Errata Sheet

This Errata Sheet contains corrections or changes made after the publication of this manual.

Product Family: DL405
 Manual Number: D4-ANLG-M
 Revision and Date: 5th Ed., Rev. A; July 2004

Page 7-4. Module jumper locations have changed as well as the order of the jumpers.

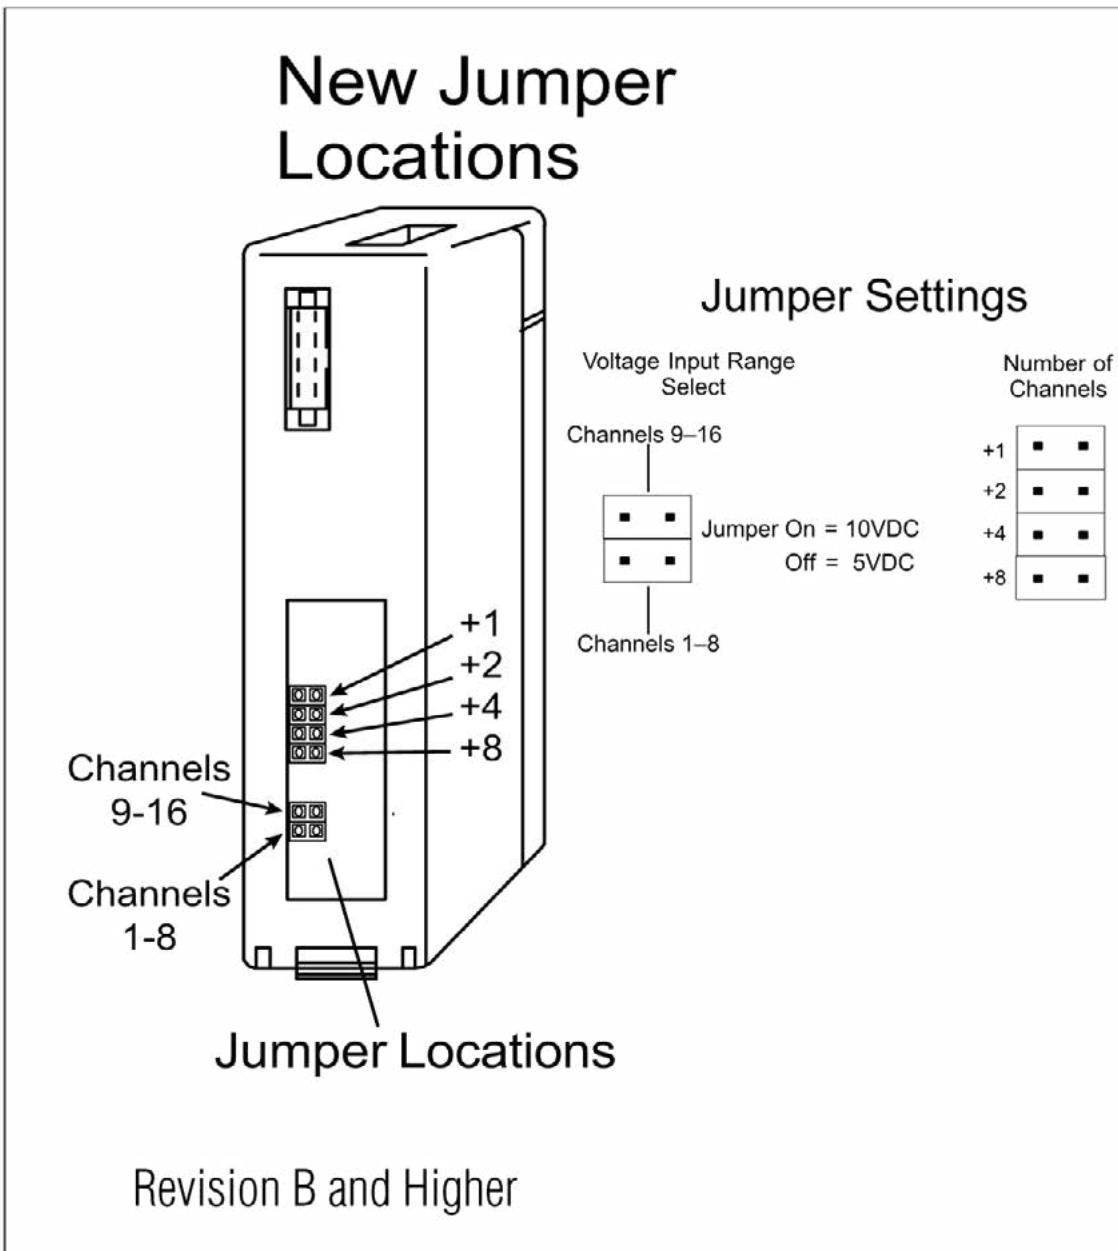
NOTICE: New jumper location and arrangement!

Page 3-11. Current Loop Transmitter Impedance

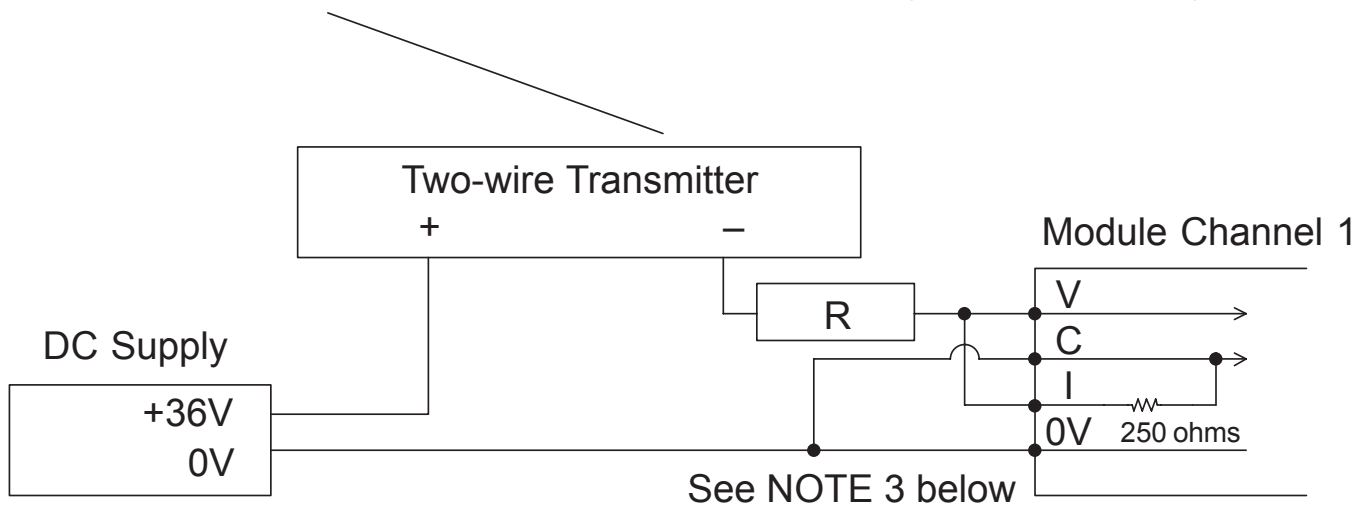
Replace the example drawing with this one. Connections were added between the power supply 0V terminal, the 0V CH1 terminal, and the CH1 common terminal. Also, the "See NOTE 3 below" note was added.

NOTE 3: When a differential input is not used, 0V should be connected to C of the channel.

Page 4-8. Wiring Diagram

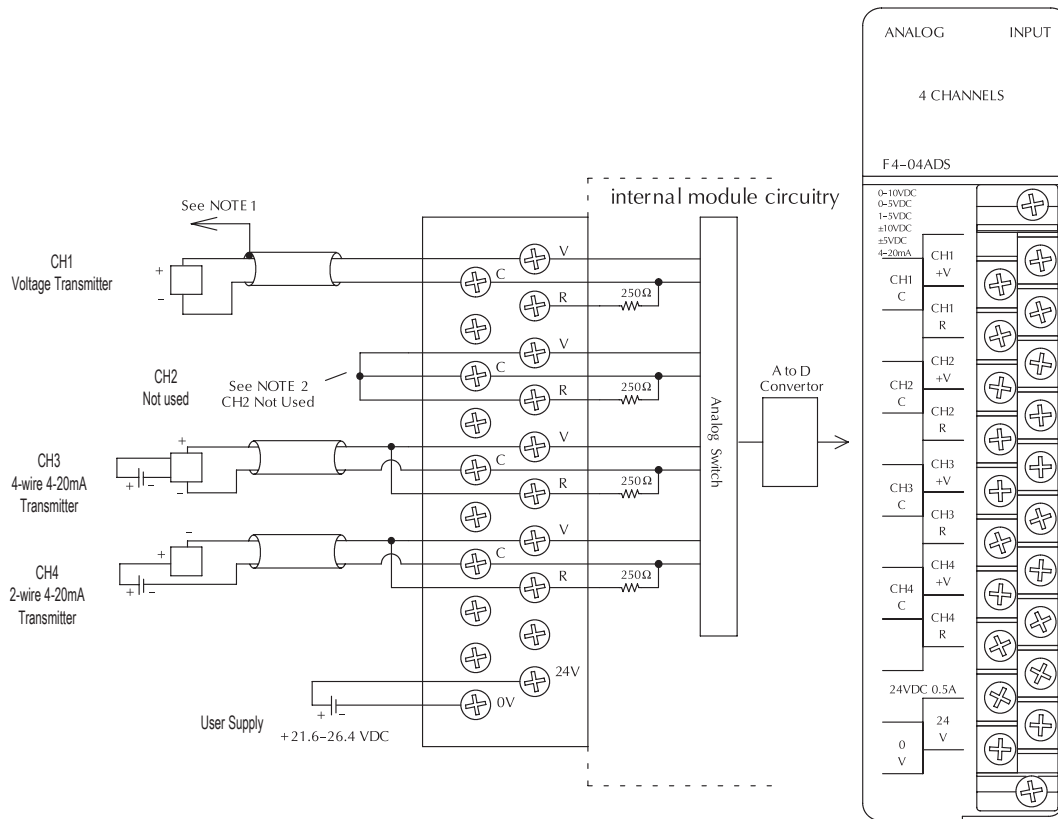
Replace the wiring diagram with this one. The connections for CH3 and CH4 were incorrect. They did not show that external power is required. Examples for wiring 2-wire and 4-wire current transmitters was added.

Changes to Chapter 7: Title page

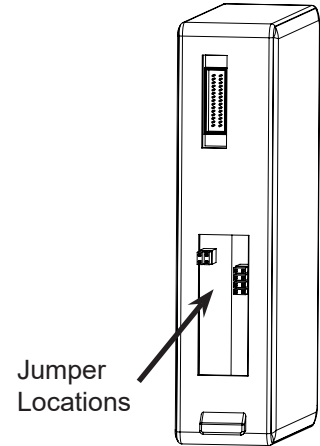
The title page mistakenly calls this an 8-point module; it is actually 16 points

Pages 8-7 and 10-10. Wiring Diagram

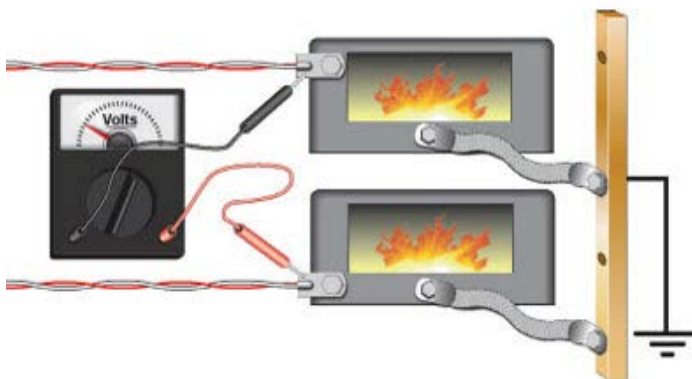
Add the following note and drawing to the wiring diagrams for both of these thermocouple modules.

With grounded thermocouples, take precautions to prevent having a voltage potential between thermocouple tips. A voltage of 1.25V or greater between tips will skew measurements.

Page 9-7. Connecting the Field Wiring; RTD - Resistance Temperature Detector; Lead Detection for RTD Sensors

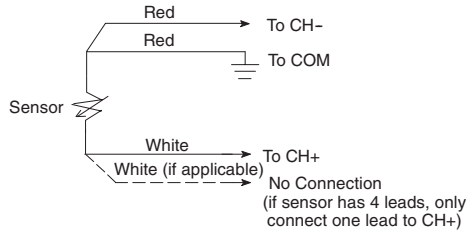
Replace the wiring diagram with this one. The wire lead colors changed. (The two black leads changed to red and the two red leads changed to white.)

Page 18-5. Wiring Diagram

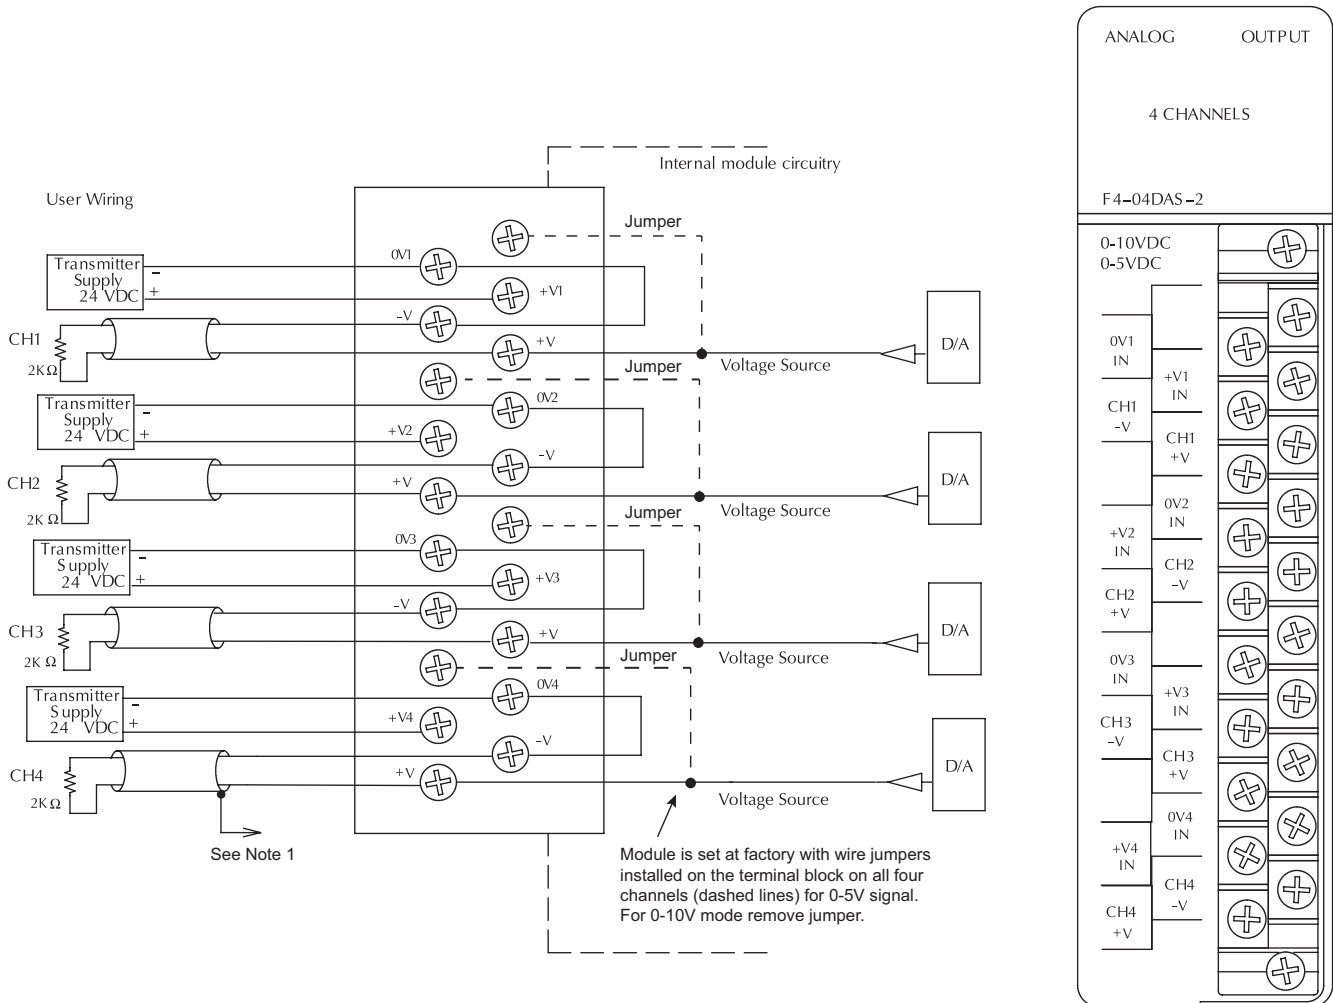
In 2008 the module was redesigned and the range selection jumpers on the back of the module were eliminated. The range selection is now done by a wire jumper for each channel located on the terminal block. This wiring diagram was revised to show these jumpers.
